SUNNY MEWS
GREEN WALL

GLOUCESTER
AVENUE

DESIGN CHANGE COMMENTARY

SUNNY MEWS GREEN WALL - MATERIALS

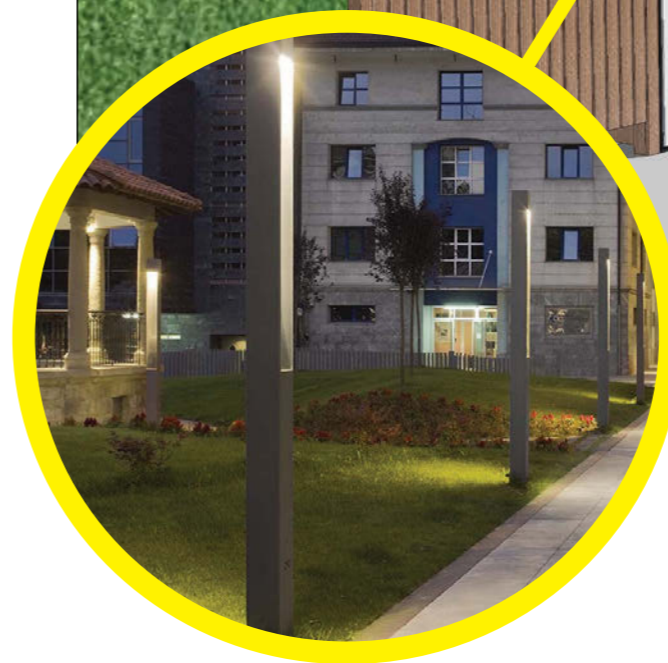
4. **SUNNY MEWS RESIDENTS**
WE WILL NOT ACCEPT 100MM SPACES BETWEEN THE STRUTS OF WOOD. WE WANT THE SAME SPACING AS THE BACK WALL OF THE CAR PARK. THE BOARDS ARE OF WESTERN RED CEDAR, 70MM X 20MM AND THE GAP BETWEEN EACH BOARD IS 8MM. IF YOU HAVE A PROBLEM WITH LIGHT THEN YOU WILL NEED TO MODIFY YOUR BUILDING DESIGN.

8. **SUNNY MEWS RESIDENTS**
THE WOOD TO BE WESTERN RED CEDAR TO MATCH THE BACK WALL OF THE CAR PARK.

9. **SUNNY MEWS RESIDENTS**
WE WILL TAKE HORTICULTURAL ADVICE AS TO WHAT FOLIAGE IS TO BE PLANTED AND OUR PROVISIONAL THOUGHTS ARE A VARIEGATED HOLLY. WE WANT PLANTING THAT IS EVERGREEN AND LOW MAINTENANCE.

DESIGN TEAM RESPONSE.
NOTED. THE PROPOSED FENCE WILL USE WESTERN RED CEDAR.

DESIGN TEAM RESPONSE.
NOTED. THE PRESENTED DESIGN COMPLIES WITH THIS REQUEST.

DESIGN TEAM RESPONSE.
NOTED. A VARIEGATED HOLLY IS INCLUDED WITHIN THE DESIGN.

SUNNY MEWS GREEN WALL - LIGHTING

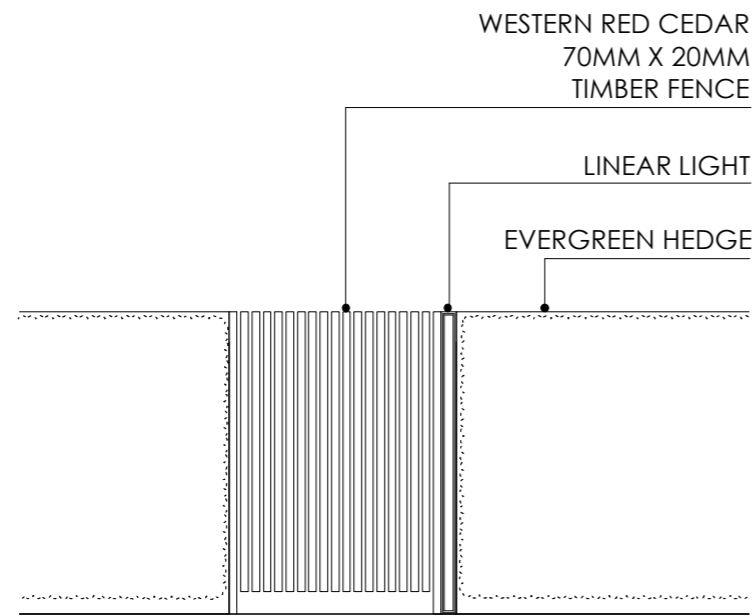
6. **SUNNY MEWS RESIDENTS**
THERE ARE NO DETAILS OF THE LIGHTING. WE NEED TO ENSURE THE LUX LEVELS AND THE FLOODLIGHTS ILLUMINATE THE WHOLE WIDTH OF THE PATHWAY. ALSO, THERE NEEDS TO BE CLARIFICATION ABOUT THE DOWNLIGHTER AT THE END.

10. **THE LIGHTS SHOULD BE FLOOD LIGHTS THAT WILL ILLUMINATE THE WHOLE OF THE PATHWAYWITHOUT ANY POCKETS OF SHADOW. THE LUX LEVELS AND NUMBER OF LIGHTS REQUIRED WILL BE ADVISED BY YOUR ARCHITECT.**

DESIGN TEAM RESPONSE.
LIGHTING FIXTURES PRESENTED. LUX LEVELS ARE SUFFICIENT.

DESIGN TEAM RESPONSE.
LIGHTING PRODUCTS PRESENTED. LUX LEVELS WILL BE SUFFICIENT.

Project
173_44 Gloucester Avenue
Drawing Title
SUNNY MEWS BOUNDARY

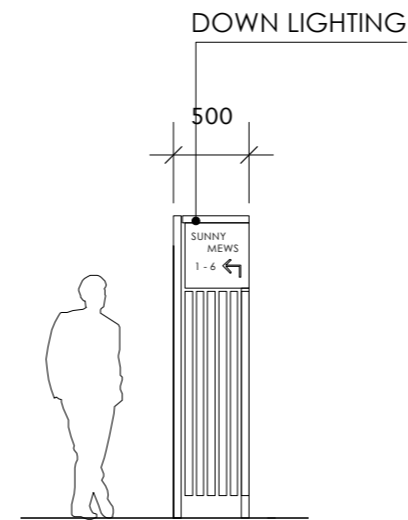
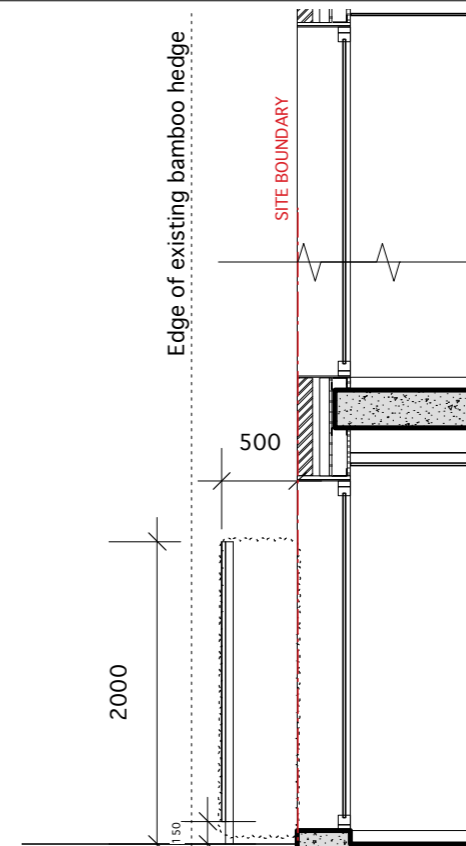
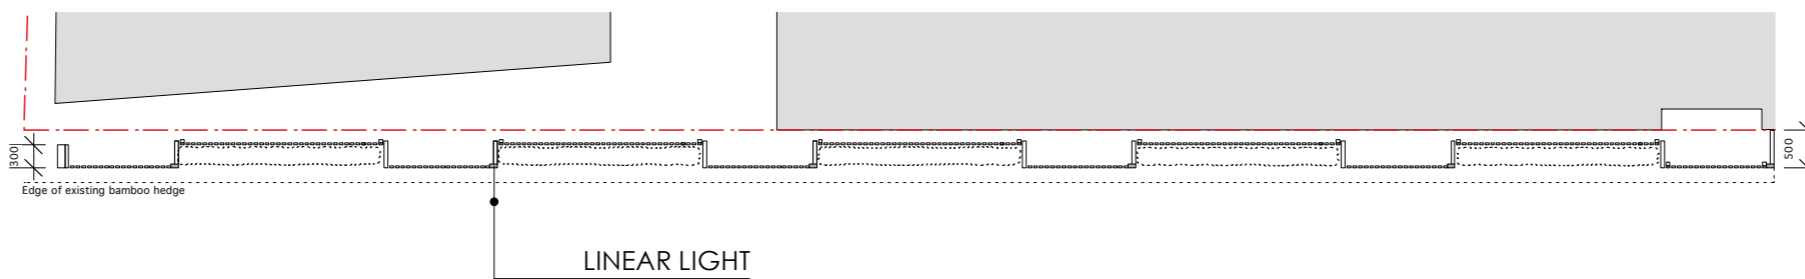
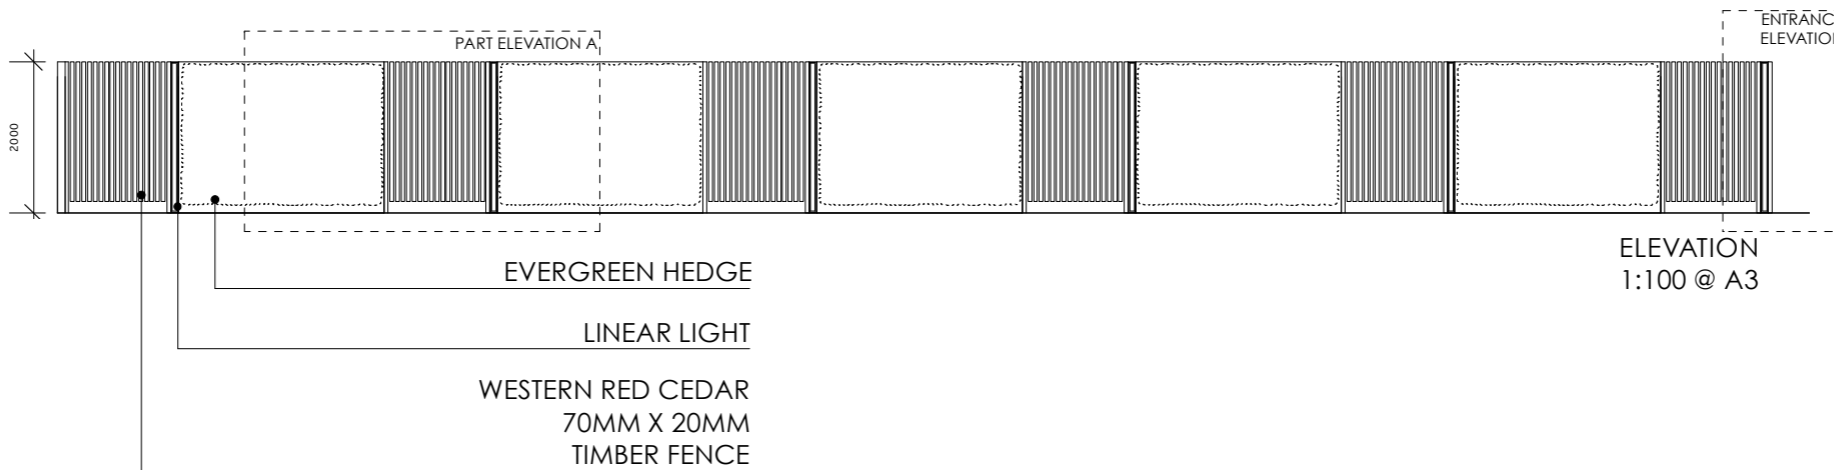
2. **SUNNY MEWS RESIDENTS**
THE FENCE IS NOT HIGH ENOUGH. WE WANT A MINIMUM OF 2 METRES, BETTER STILL IT SHOULD MATCH THE HEIGHT OF THE BACK CAR PARK WALL.

5. **SUNNY MEWS RESIDENTS**
THE SIGNAGE ON THE EDGE OF THE WALL IS UGLY AND, AS WE SAID IN OUR DESIGN BRIEF, THERE IS NO NEED FOR THE NUMBERS 48 AND 50 TO APPEAR AS THIS IS MISLEADING.

11. **SUNNY MEWS RESIDENTS**
THE HEIGHT OF THE WOODWORK TO BE THE SAME HEIGHT AS THE BACK WALL OF THE CAR PARK TO CONTINUE THE LINE.

DESIGN TEAM RESPONSE.
THE HEIGHT OF THE FENCE HAS BEEN INCREASED TO 2M.

DESIGN TEAM RESPONSE.
NOTED. THE SIGNAGE MAKES REFERENCE TO SUNNY MEWS ONLY.

DESIGN TEAM RESPONSE.
THE HEIGHT OF THE FENCE HAS BEEN INCREASED TO 2M.

SUNNY MEWS
BOUNDARY

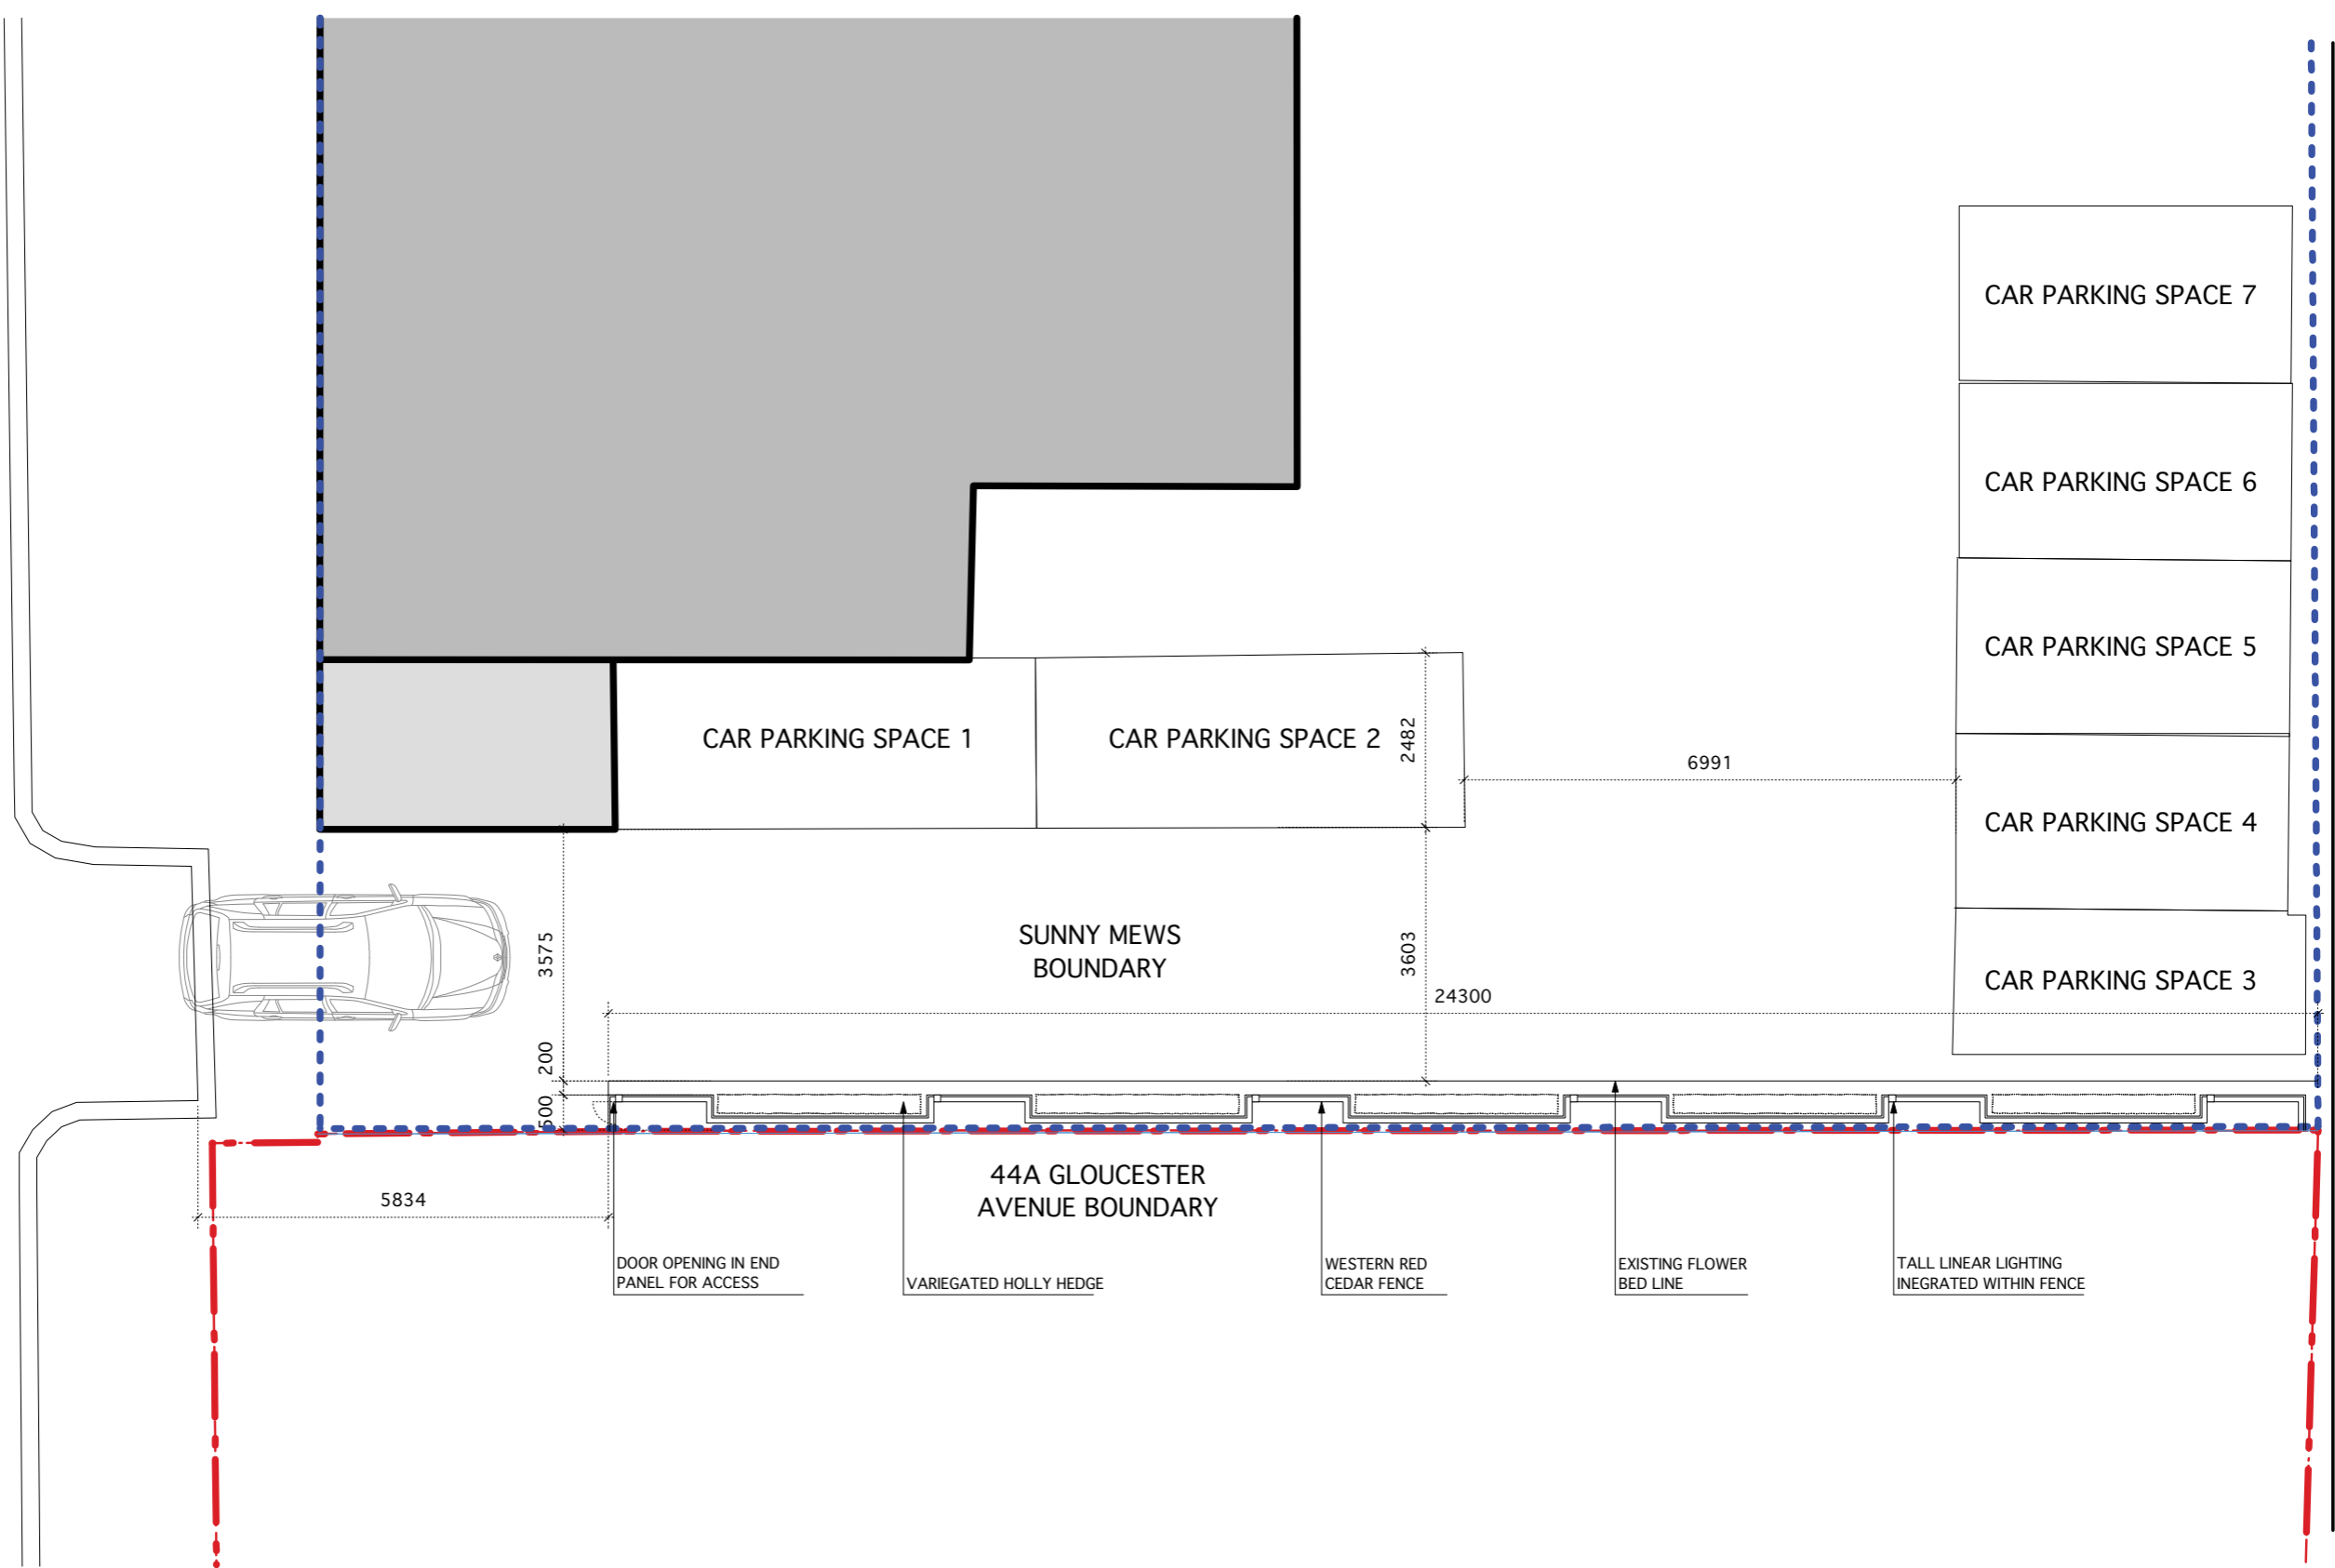
3. **SUNNY MEWS RESIDENTS**
THE FENCE IS TOO FAR FORWARD IN THE FLOWERBED. IT SHOULD BE IN THE MIDDLE, WHICH IS THE POSITION OF THE PRESENT HOARDING ADJACENT TO CAR PARK SPACE 7. SEE SKETCH DIAGRAM WITH MEASUREMENTS.

12. **SUNNY MEWS RESIDENTS**
THE FENCE TO BE POSITIONED IN THE MIDDLE OF THE "FLOWER BED". THIS IS THE POSITION OF THE PRESENT HOARDING ADJACENT TO CAR PARK SPACE 7.

13. **SUNNY MEWS RESIDENTS**
THE END PANEL AT THE GATE ENTRY TO FIT FLUSH AGAINST THE WALL BUT THE PANEL TO BE HINGED TO ALLOW ACCESS.

DESIGN TEAM RESPONSE.
NOTED. THE FENCE HAS BEEN SET OUT 200MM FROM THE CURRENT FLOWERBED.

DESIGN TEAM RESPONSE.
NOTED. THE FENCE HAS BEEN SET OUT 200MM FROM THE CURRENT FLOWERBED.FLOWERBED.

DESIGN TEAM RESPONSE.
NOTED.
